# VEHICLE RECALL

**G-04515**  
**September 2004**

**SUBJECT: SAFETY RECALL (U.S., EXPORT)**  
**BRAKE GROUP ATTACHMENT on certain 9200*i*,  
9400*i*, and 9900*i* models built 7/26/2004 thru  
7/29/2004**

**Figure 1 – Rear Brake Group Mounting**

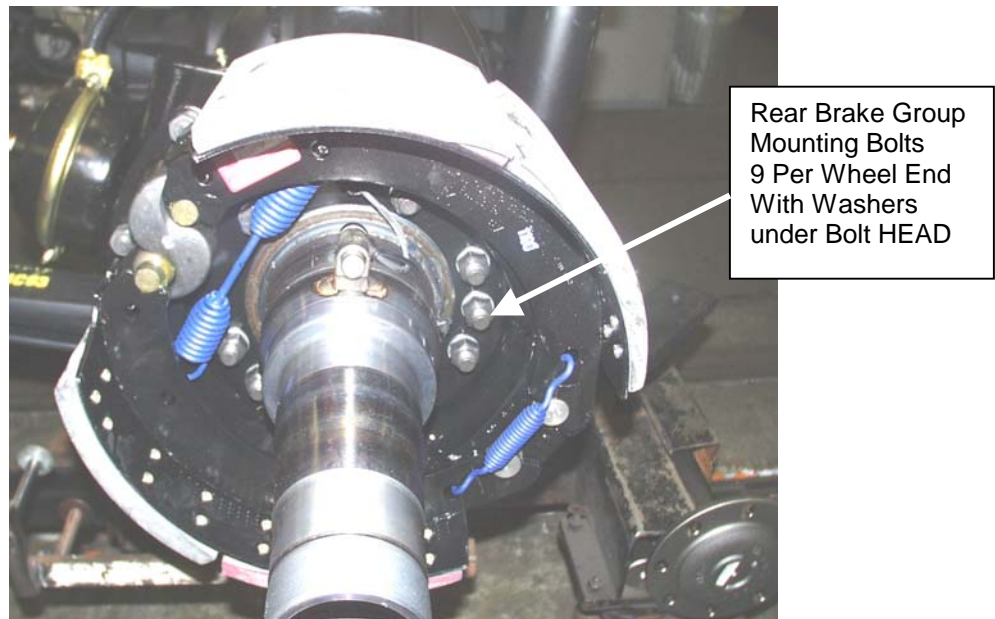
Only eight (8) bolts may have been installed in the brake group mounting to the rear axles of some of the above units. The brake group, an assembly that includes the brake shoes, air chambers, slack adjusters, and spider, is normally attached to the axle housing with nine (9) bolts. When one or more bolts are missing, the structural integrity of the brake group mounting is questionable. This may result in a loss of braking ability on the rear axles without warning and may result in **property damage, personal injury or death.**

1. Remove rear wheel assembly (rim and tire).
2. Release park brake.
3. Remove rear brake drum (or hub). This may require loosening the brake adjustment.
4. Install missing nut, bolt, and washer. There should be a total of nine (9) bolts per wheel end.

**NOTE: INSTALL HEAD OF BOLT IN TOWARDS CENTERLINE OF VEHICLE. INSTALL WASHER UNDER BOLT HEAD ONLY.**

5. Torque new rear brake group bolt to **175-190 Lbf-Ft (240-260 Nm)**.
6. Perform a torque check on remaining bolts to **175-190 Lbf-Ft (240-260 Nm)**.
7. Install rear brake drum (or hub).
8. Adjust outer wheel bearing adjusting nut and check end play with dial indicator if hub was removed.
